**TOWN OF MOUNTAIN VILLAGE  
REGULAR DESIGN REVIEW BOARD MEETING AGENDA  
THURSDAY NOVEMBER 3<sup>RD</sup>, 2022 10:00 AM  
MOUNTAIN VILLAGE TOWN HALL  
455 MOUNTAIN VILLAGE BLVD, MOUNTAIN VILLAGE, COLORADO  
TO BE HELD HYBRID THROUGH ZOOM:**

**DESIGN REVIEW BOARD MINUTES  
TOWN OF MOUNTAIN VILLAGE REGULAR  
DESIGN REVIEW BOARD MEETING  
OCTOBER 6<sup>TH</sup>, 2022**

Lot SS811  
2 MV Blvd  
Mtn. Village, CO

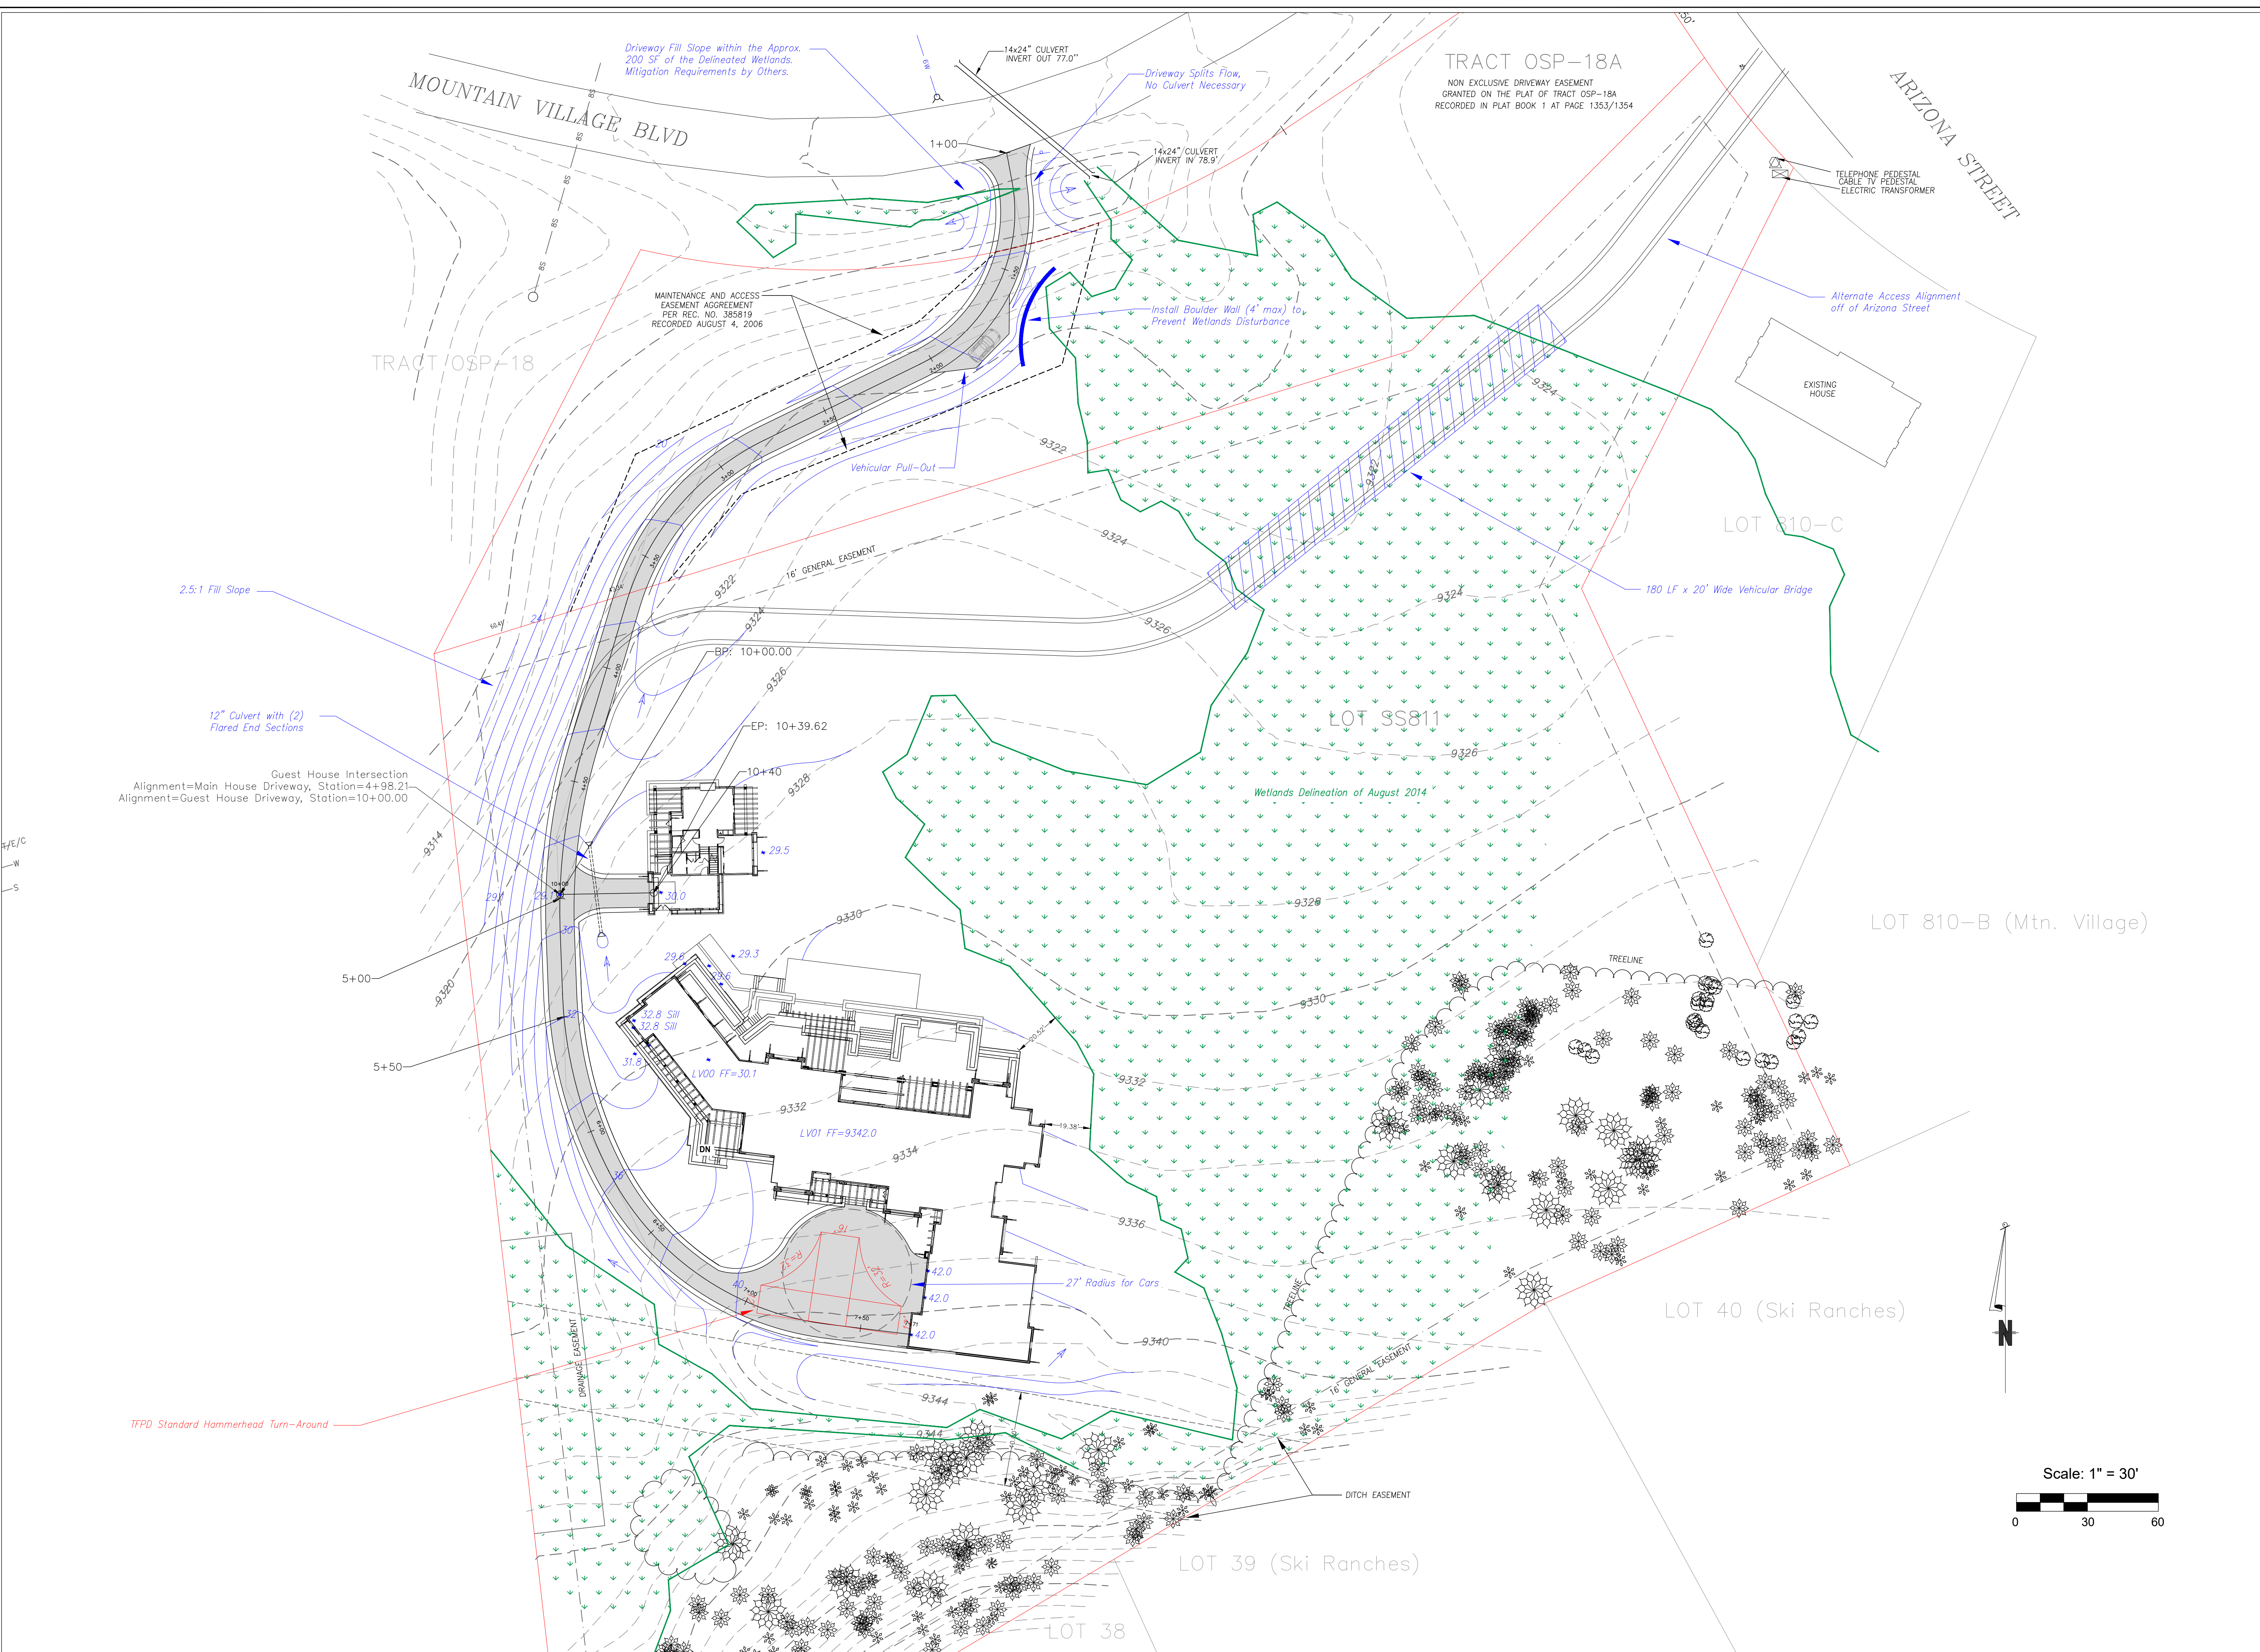
The DRB reviewed this case at the October 6, 2022 meeting and continued the discussion to this DRB meeting. The DRB requested additional information about a proposed pond, the site's access, and the building design. In response to the DRB meeting, the applicant has provided an updated set of plans and additional information, which is included in Attachment A. These changes include:

1. The arched non-orthogonal windows have been removed from the design and replaced with a more traditional rectangle design.
2. All stucco has been removed from the proposed design and replaced with board and batten siding. A full materials board will be provided at the meeting.
3. The proposed pond has been removed from the landscaping plans.
4. The applicant has provided some information about alternative site access from Arizona Street and the potential impacts to the wetlands from the Arizona Street and Mountain Village Boulevard locations. Additional information will be provided at the DRB meeting.

A.1

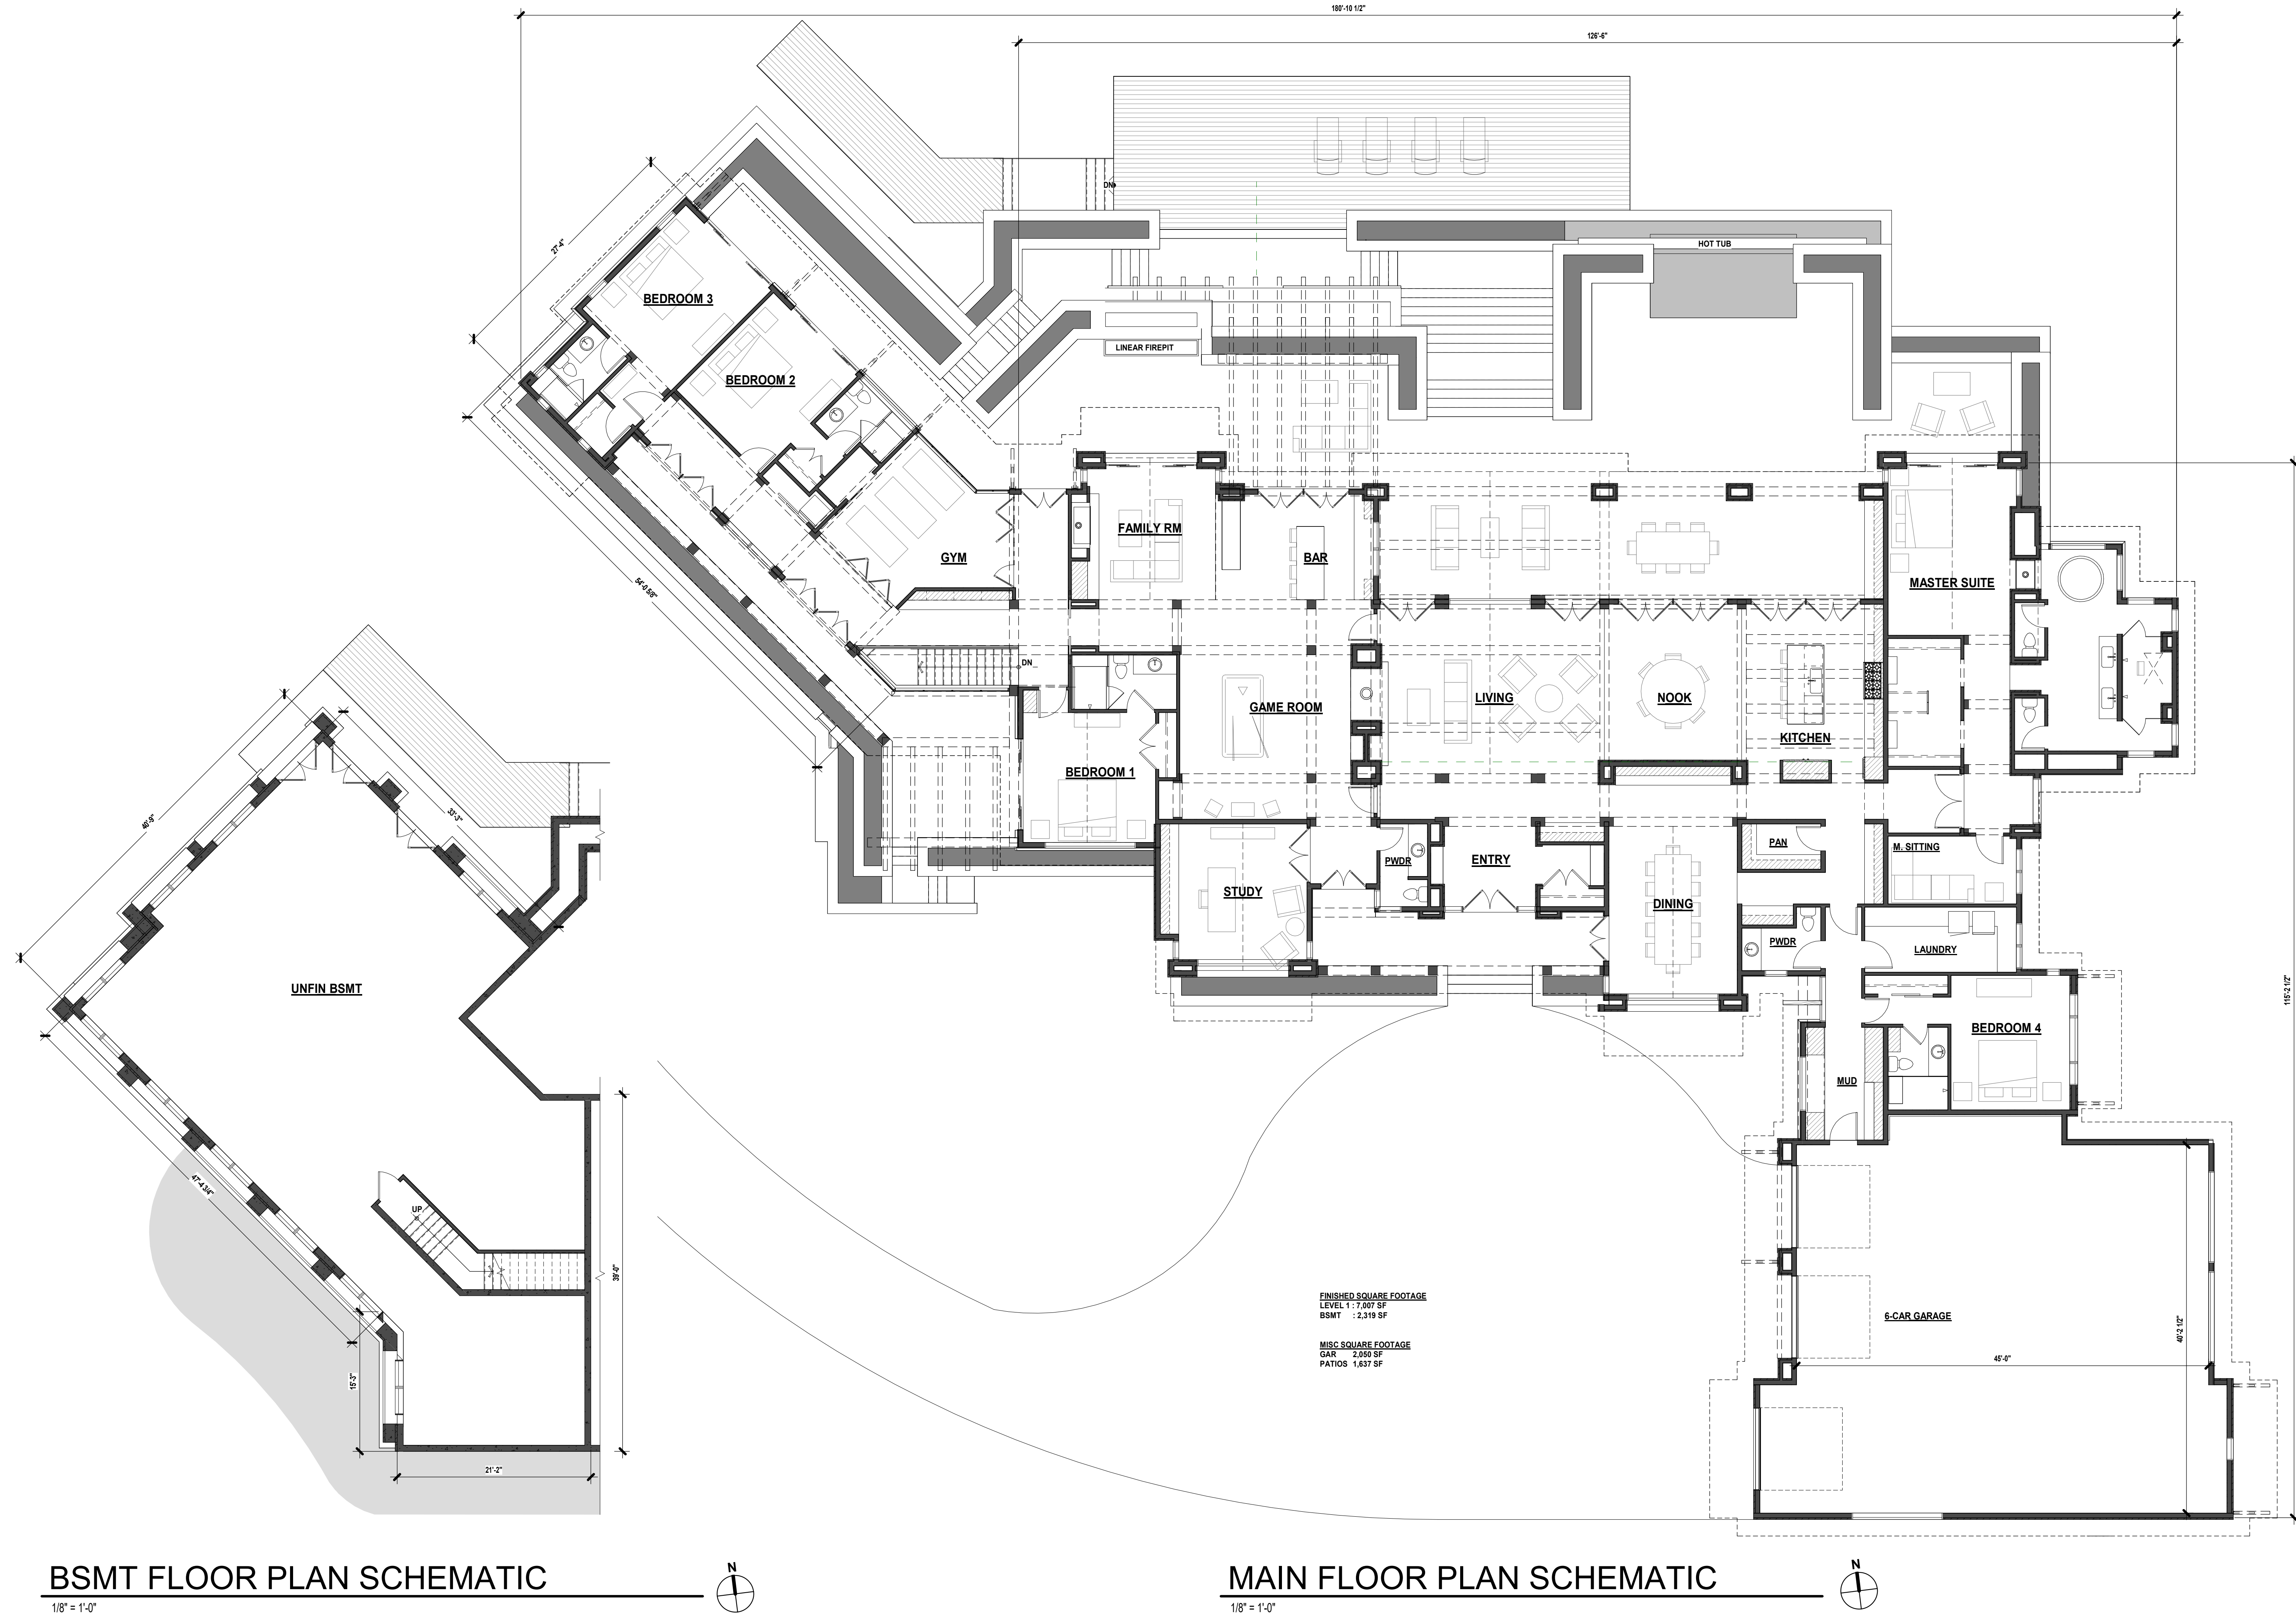
*Staff: The applicant has shown six interior parking spaces for the main house and one interior parking space for the guest house. The applicant does not identify the two exterior parking spaces required by the CDC. The applicant is required to show the required two exterior parking spaces at part of the final review.*

- 5) *Prior to final review, the applicant shall identify the required two exterior parking spaces for the site.*
- 6) *Prior to final review, the applicant shall include an updated outdoor lighting plan in compliance with the CDC.*
